DEVELOPMENT REVIEW BOARD
SUPPLEMENTAL SUBMITTAL

PROJECT NO. PR-2022-006497

Application No. SI-2022-00124

To: City of Albuquerque Development Review Board
From: Michael Vos, AICP, Consensus Planning, Inc. 
Date: March 4, 2022
Re: PR-2022-006497 Sunport Hotel DRB Comment Responses

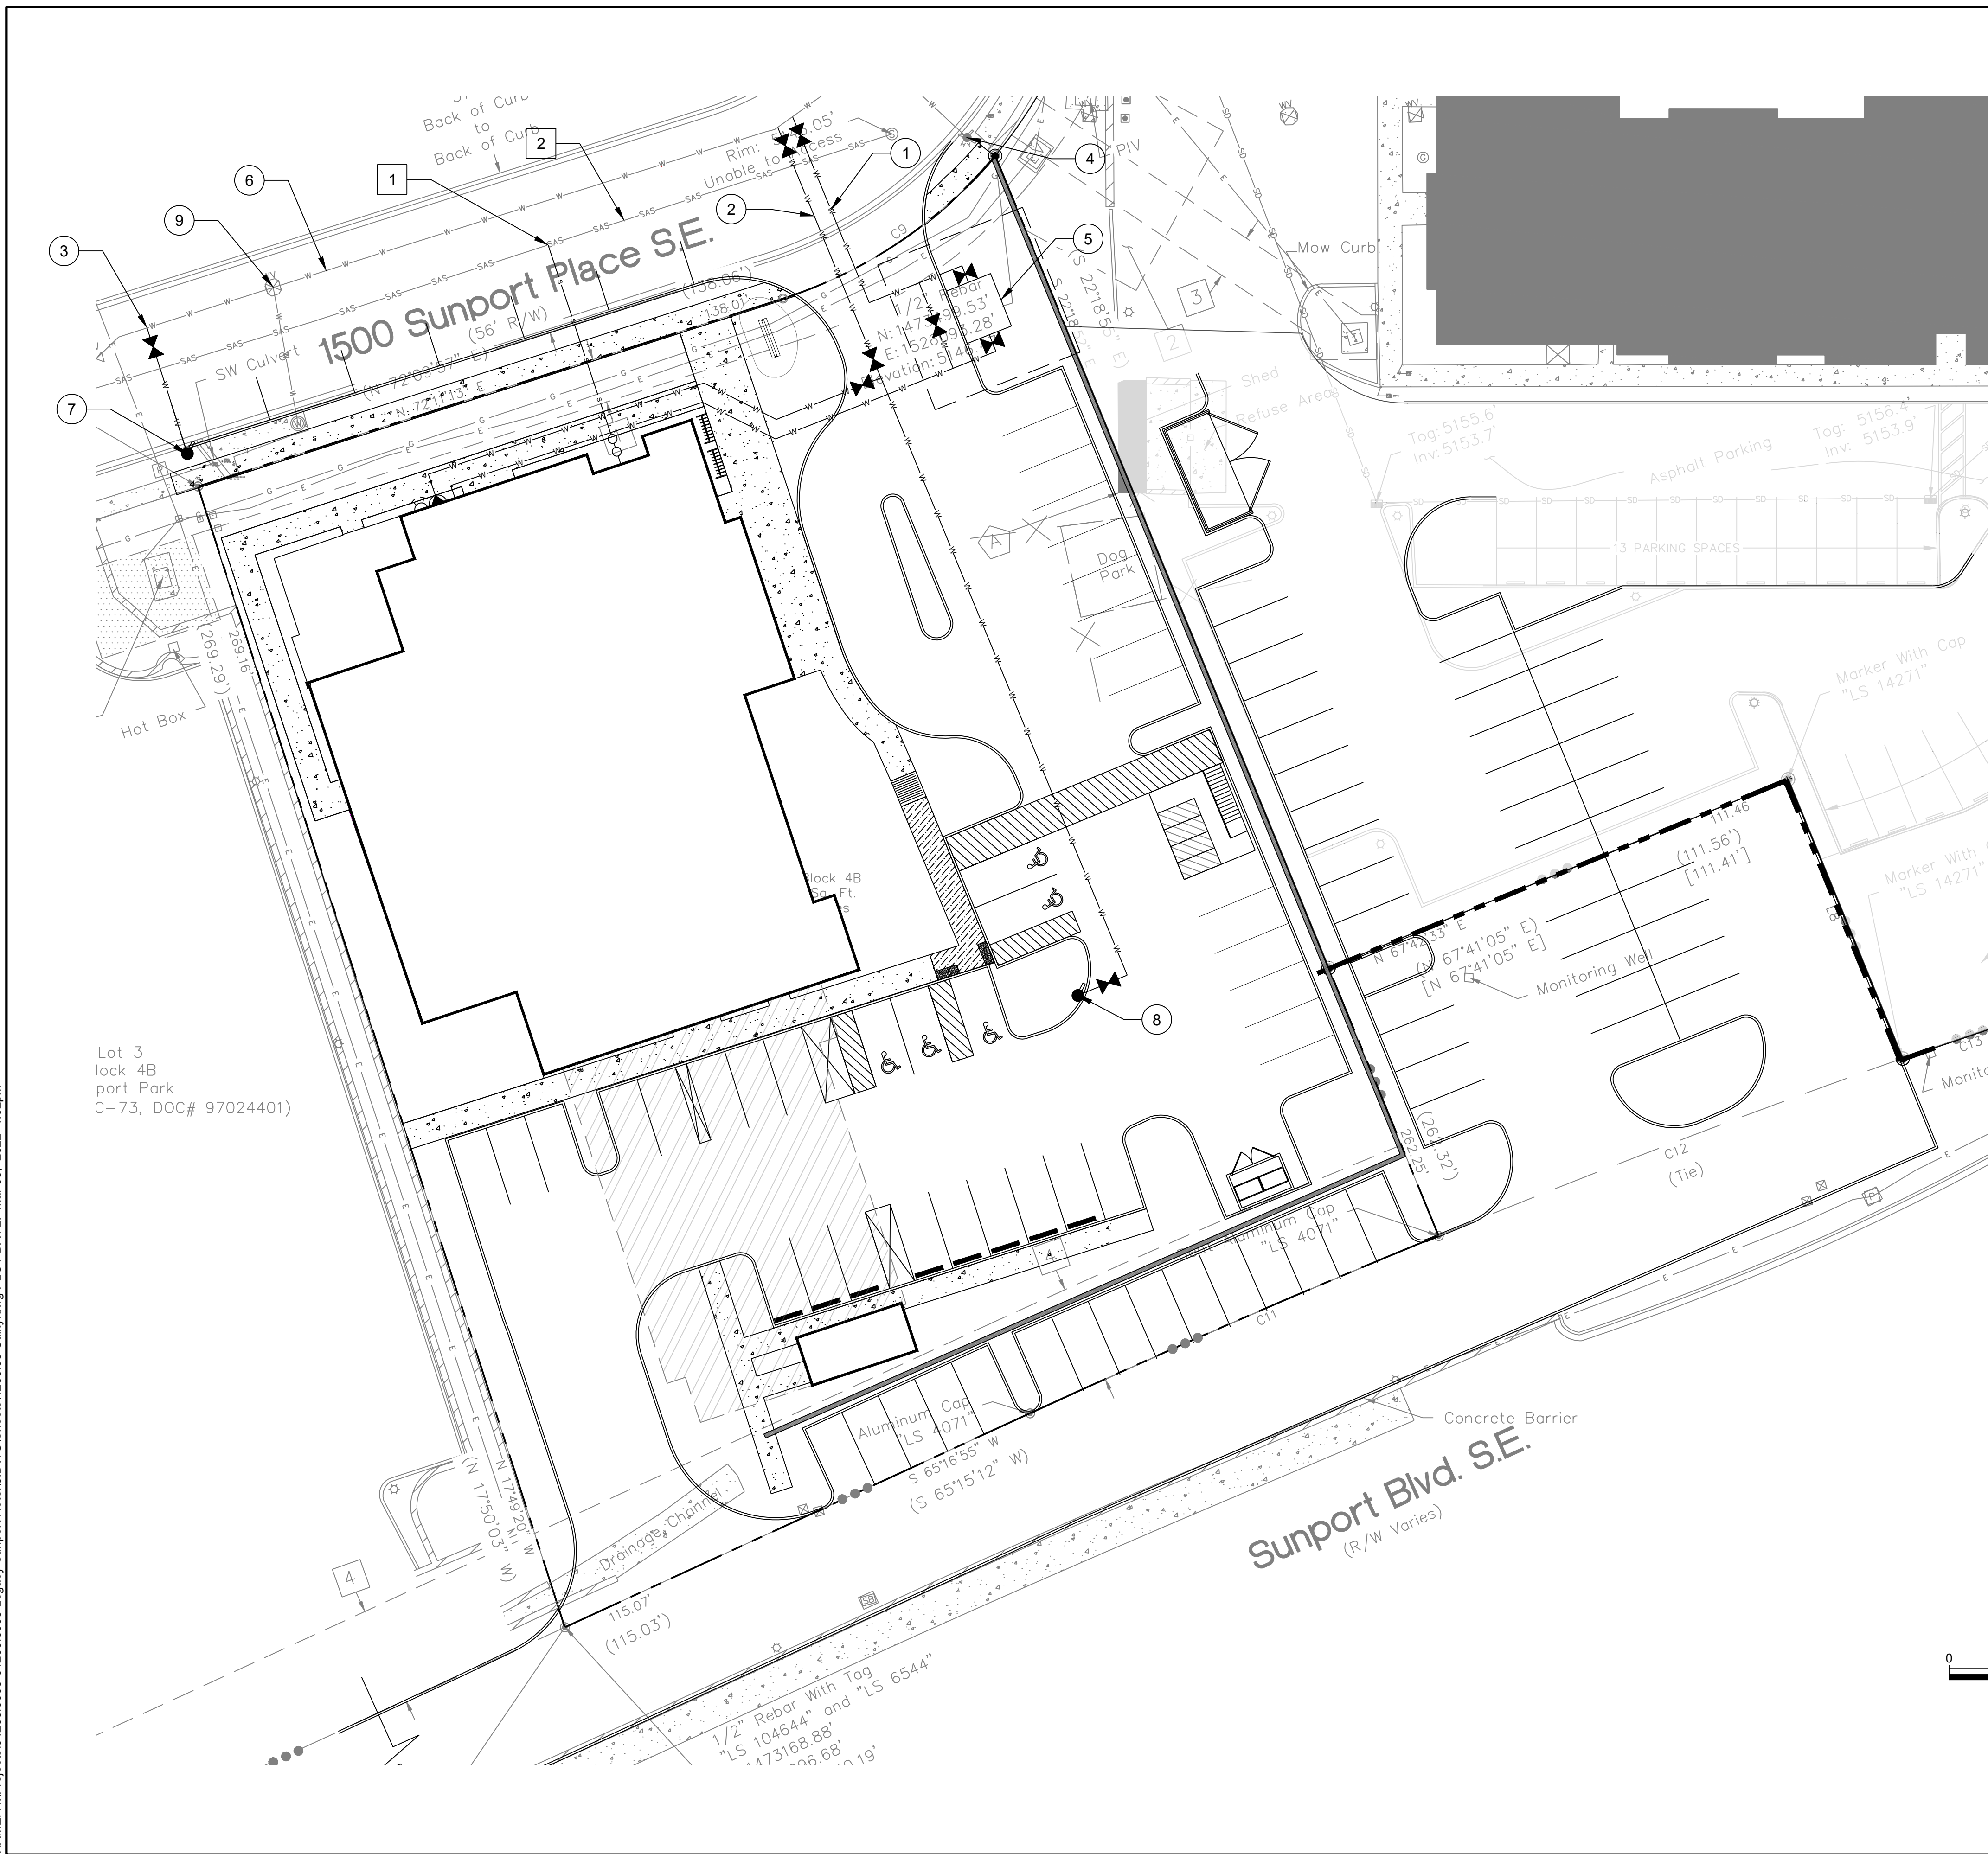
1. Hydrology has received a Grading & Drainage Plan (M15D050) on 01/13/22. The project is in Hydrology’s que.
 - *Updated grading and drainage plans are included in this submittal and will be reviewed by Hydrology, as required.*

SHEET TITLE:
FIRE 1 PLAN

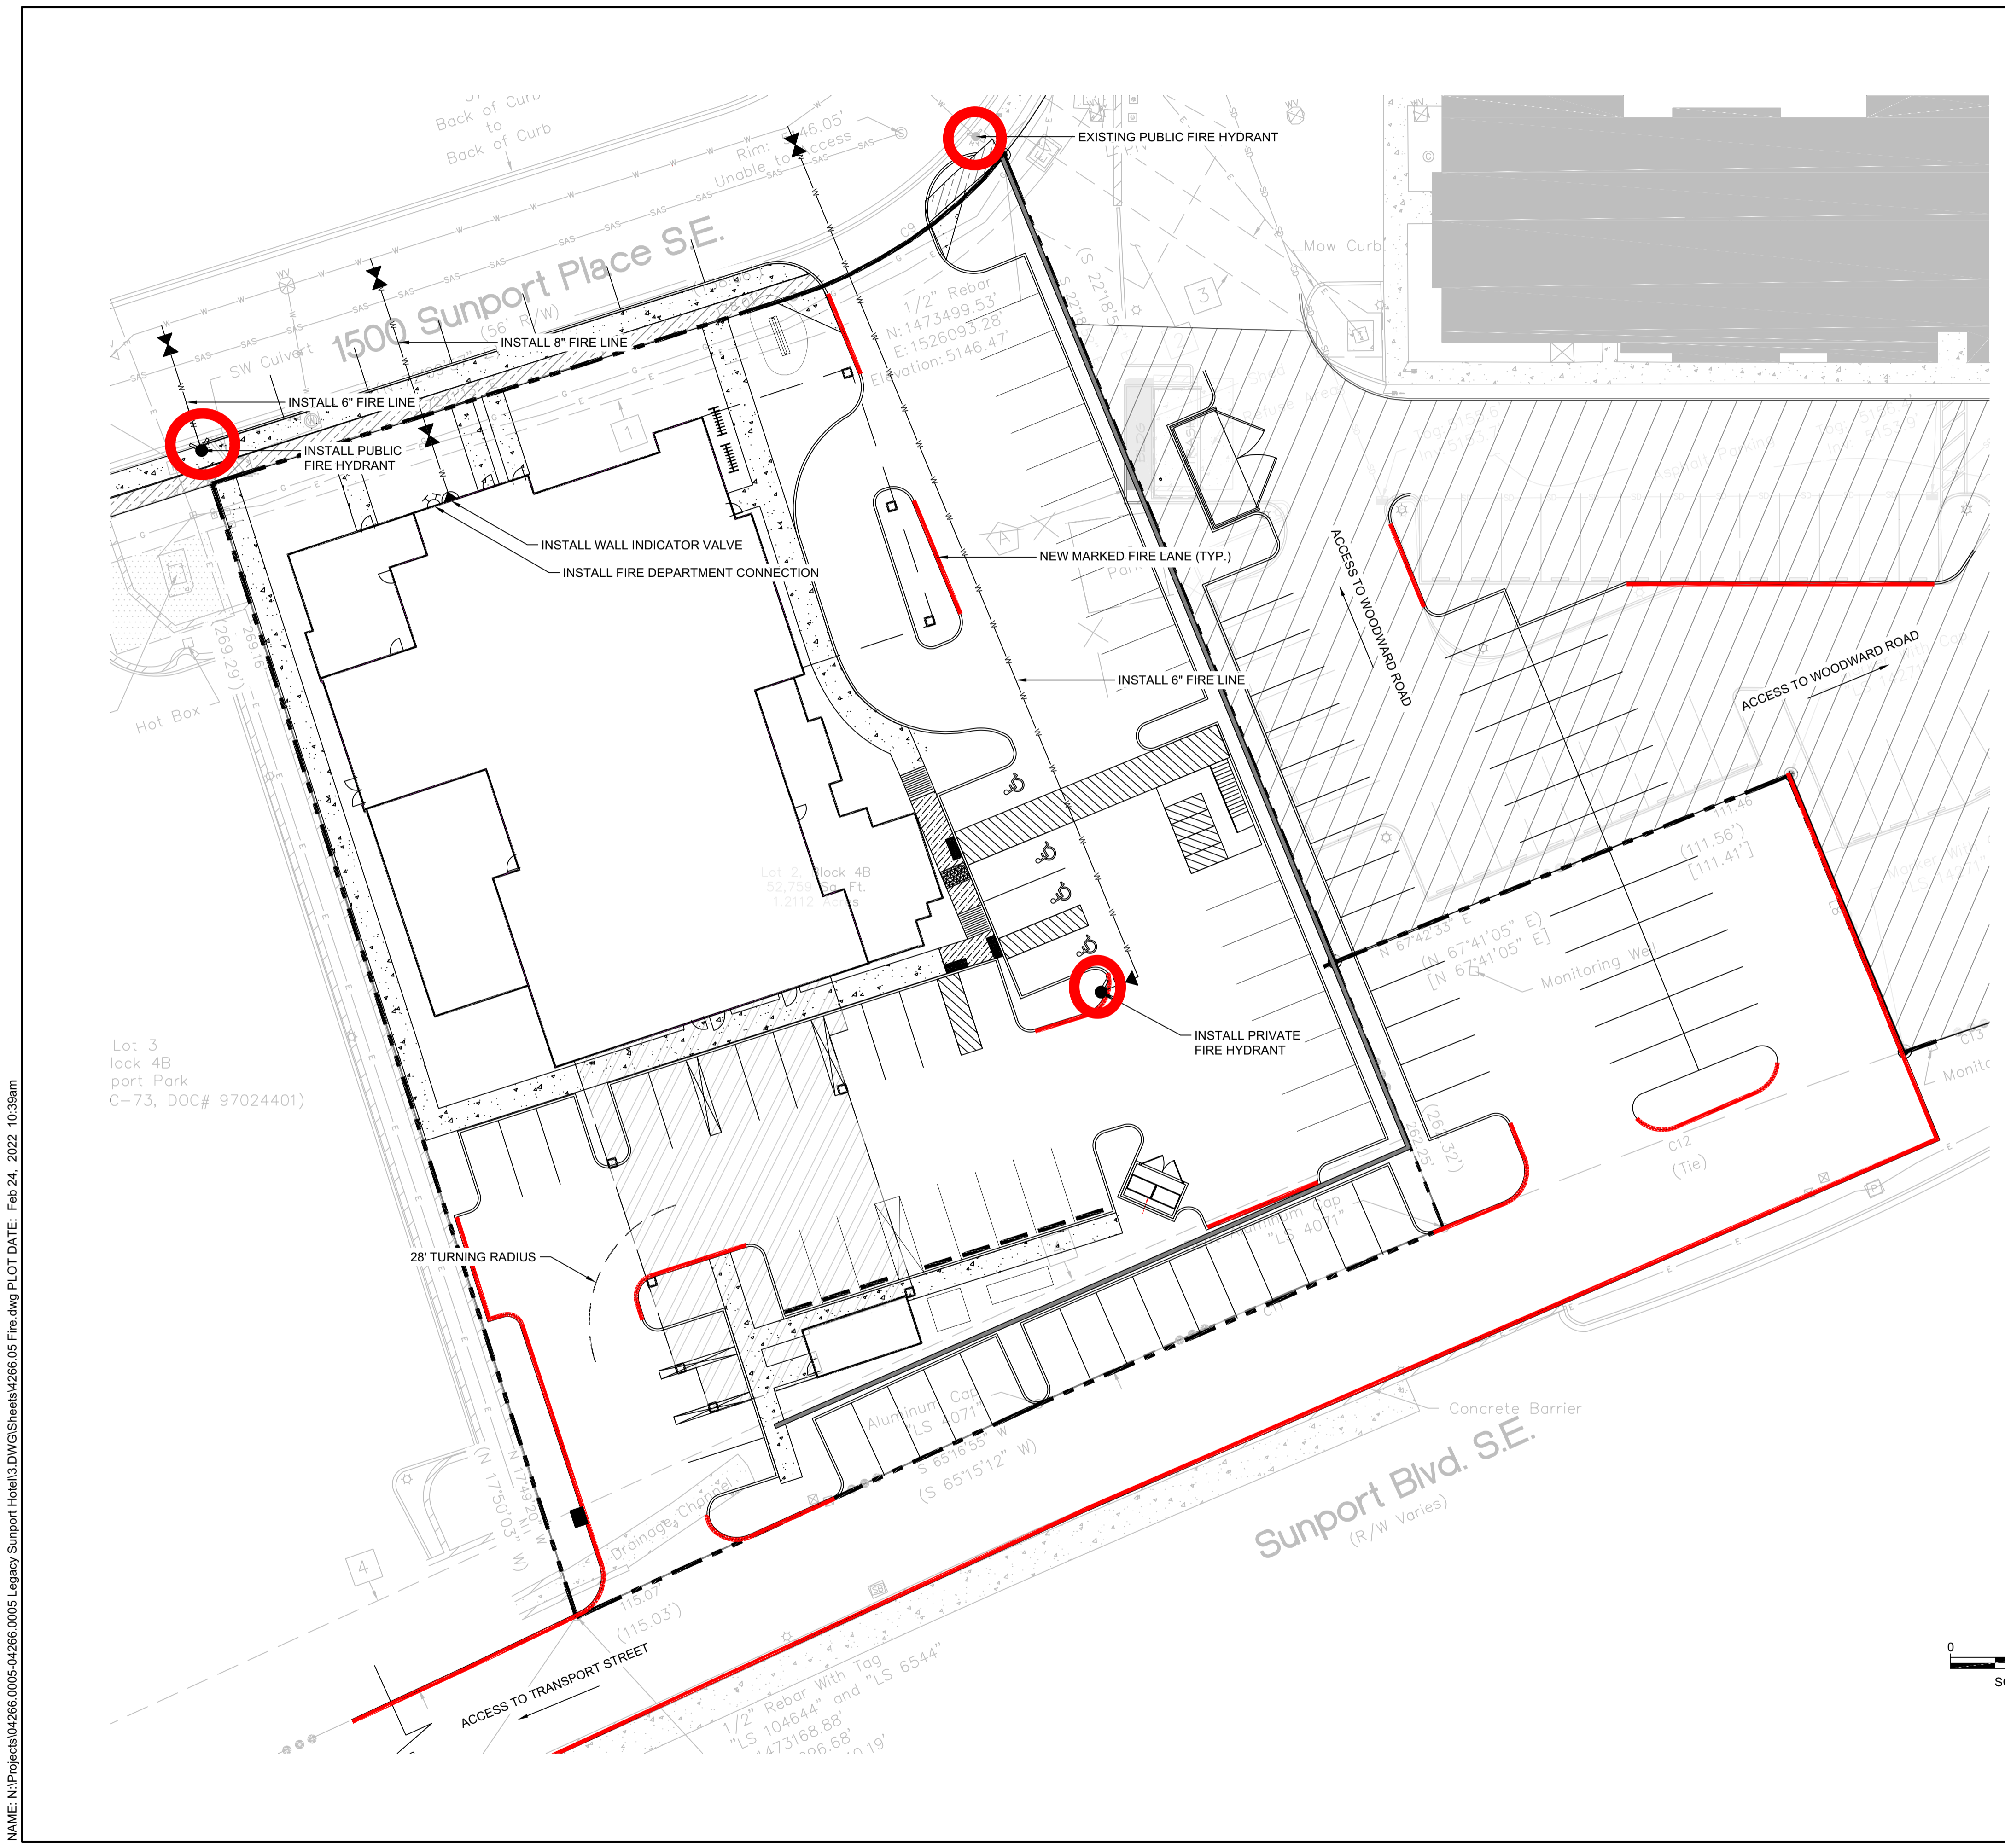
- *See response to Code Enforcement comment #8.*
7. Provide Fire-One Plan with this submittal.
 - *The approved Fire 1 plan has been added to the plan set.*
